## DEPARTMENT OF ENVIRONMENTAL QUALITY DIVISION OF RADIATION CONTROL

November 10, 1997

Please find enclosed some information brought to the attention of the Radiation Control Board regarding the Atlas tailings Final Technical Evaluation Report (FTER). At the November 5, 1997 meeting of the Utah Radiation Control Board, a Utah citizen, Peter Heaney, requested that the Board require the State to intervene on some issues relating to the FTER. During the meeting, the Division of Radiation Control (DRC) staff responded to many of Mr. Heaney's concerns and agreed with a majority of the findings in the FTER.

Re: Disparities between NRC Final Technical Evaluation Review Design of Launchable Rock Apron and US Army Corps of Engineers recommendations.

CALCULATION BRIEF  
ROCK APRON/TOE DESIGN

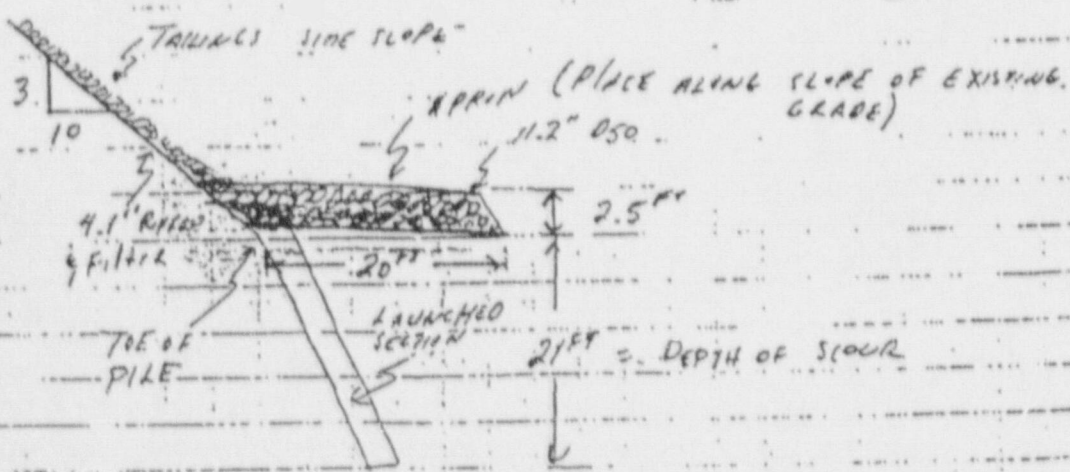
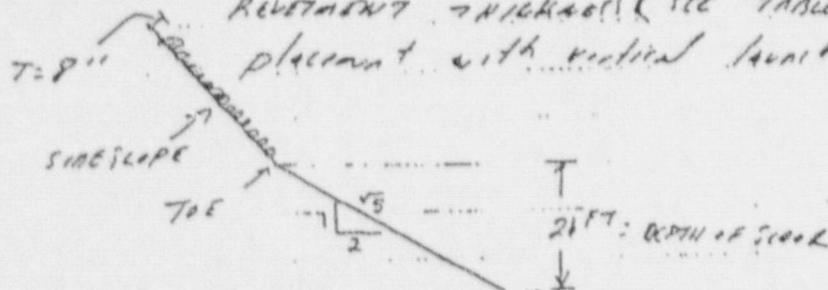
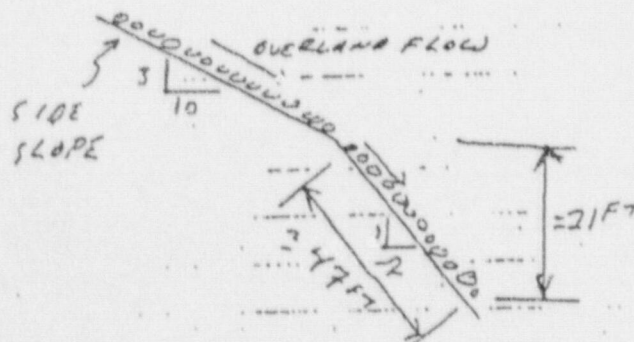
I was reviewing the Atlas Reclamation Plan, Oct 96, while composing the accompanying letter. On page 1 of Appendix O, Calculation Brief - Rock Apron/Toe Design, the  $D_{50}$  of the proposed rock apron equals 11.2". Yet on page 2, T (thickness) = 8" was used in the calculations to determine necessary volume per linear foot. Shouldn't 11.2" have been used in the calculations as this is the T (thickness) of the Bank Revetment after launch? This would result in  $21\sqrt{5} \times 11.2"/12 \times 1.5$  instead of  $21\sqrt{5} \times 8"/12 \times 1.5$ . This results in a linear foot volume requirement of 65.74 ft<sup>3</sup>/ft instead of 47 ft<sup>3</sup>/ft as calculated on page 2. This results in Rock Apron total volume requirements being 6427.9 yd<sup>3</sup> rather than the 4889 yd<sup>3</sup> or 5000 yd<sup>3</sup> (a difference of 30%) shown in the Calculation Brief on page 3, and the Final Technical Evaluation Report, Nureg - 1532.

If my calculations are correct, then please revise the FTER to account for this discrepancy.
